MEMORANDUM

FROM: GREG KROM, WATER SUPERINTENDENT

SUBJECT: KLOCK PARK SPECIAL PERMIT APPLICATION

Longitudinal Groundwater Elevation Profile Pye Brook Park Entrance to Stone Bridge on Perkins Row

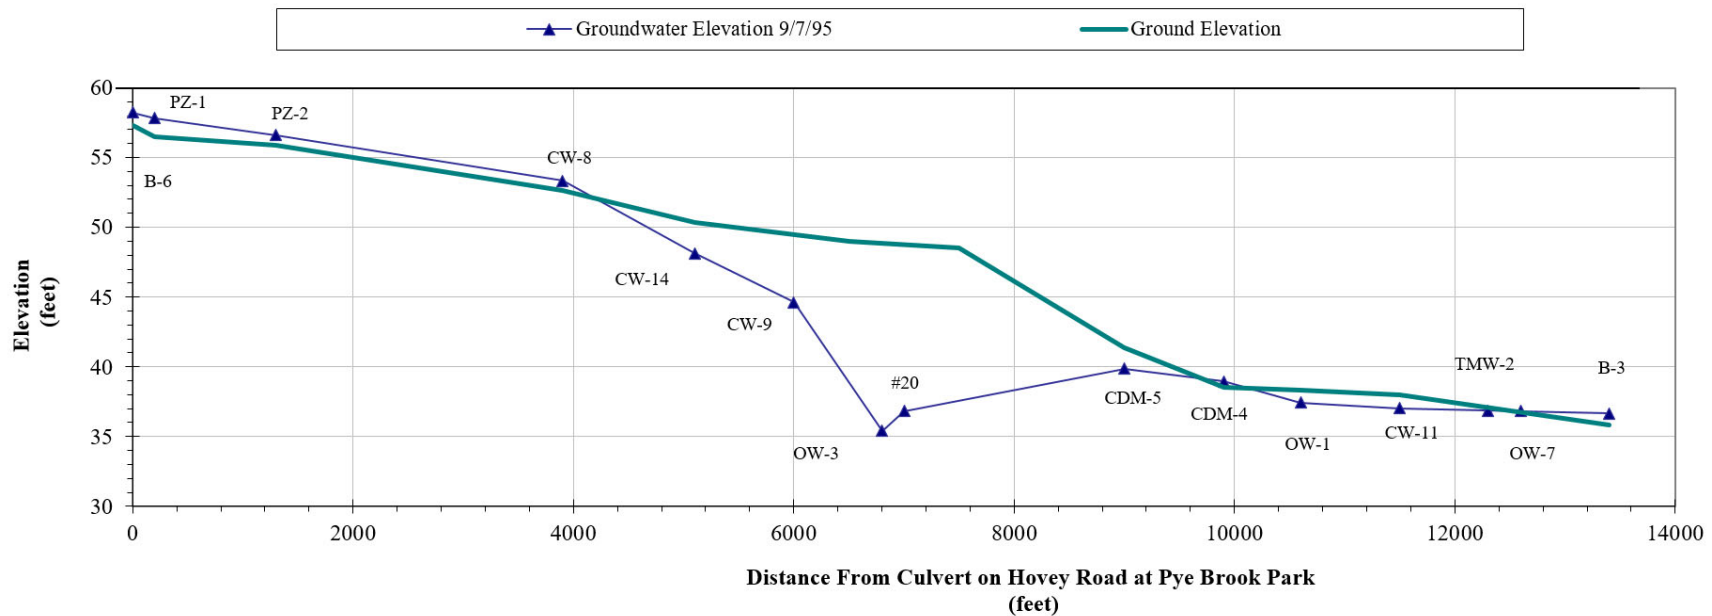
The cone is clearly evident in the attached 2-dimensional groundwater profile taken on a single day along the streams near our wells. The slope of the cone is steepest near the North Street wellfield (OW-3) and gradually returns to the natural gradient further away from the well (CDM-5). Based on this profile, it appears that on this particular day North Street lowered the natural groundwater gradient by about 12 feet and the downstream gradient returned to its normal slope somewhere between Country Motors and Brookside Road. The cone extends laterally until it reaches an impermeable soil such as Great Hill's glacial till or the combination of distance and soil type changes allow the groundwater slope to return to normal. In Topsfield's case the Zone II covers a great deal of area.
